# **8XC196NP**

## **SPECIFICATION UPDATE**

Release Date: September, 1996

Order Number 272838-002

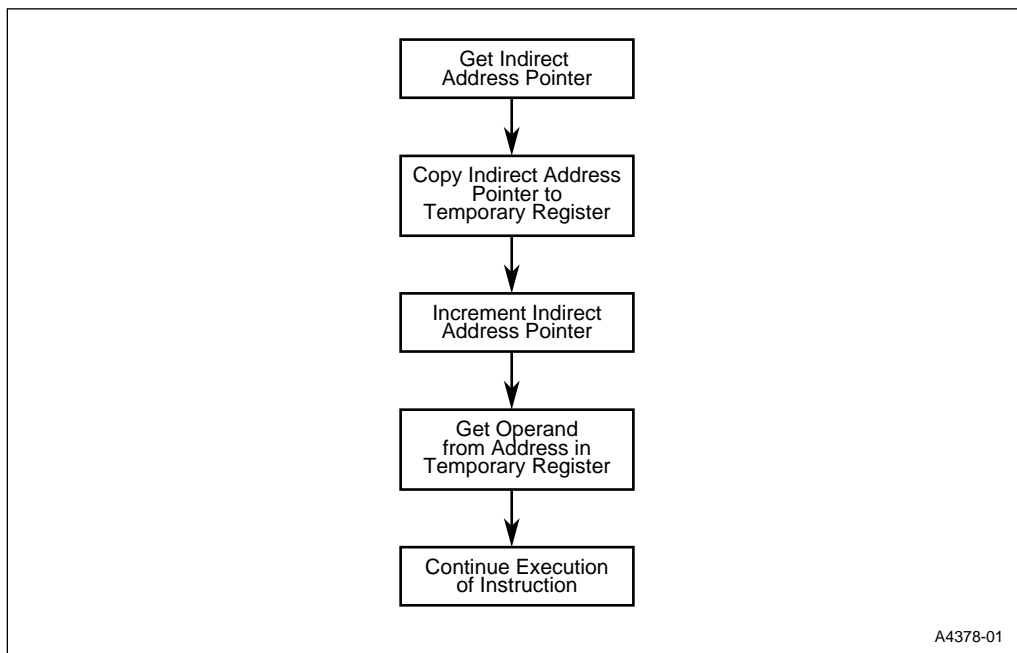
**PROBLEM:** For indirect addressing with autoincrement, a pointer that points to itself results in an access to the incremented pointer address rather than the original pointer address.

The CPU stores the pointer's value in a temporary register, increments the pointer, then accesses the operand at the address contained in the temporary register, as shown in this flowchart.

Therefore, if the pointer points to itself, the CPU accesses the operand at the incremented address contained in the pointer.

Figure 7. READY Timing Diagram (Multiplexed Bus Mode)

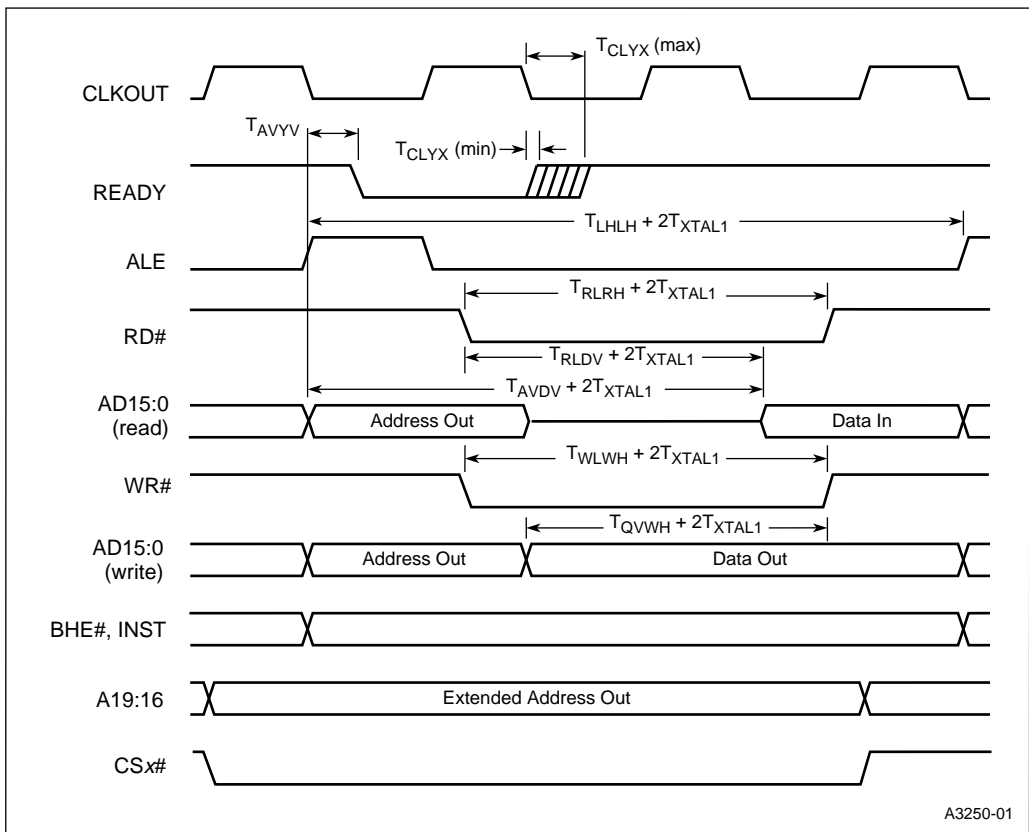
The value  $2T_{XTAL1}$  was incorrectly shown as  $T_{XTAL1}$  in the READY timing diagrams. The following two figures replace Figure 7 and Figure 9 in the datasheet.
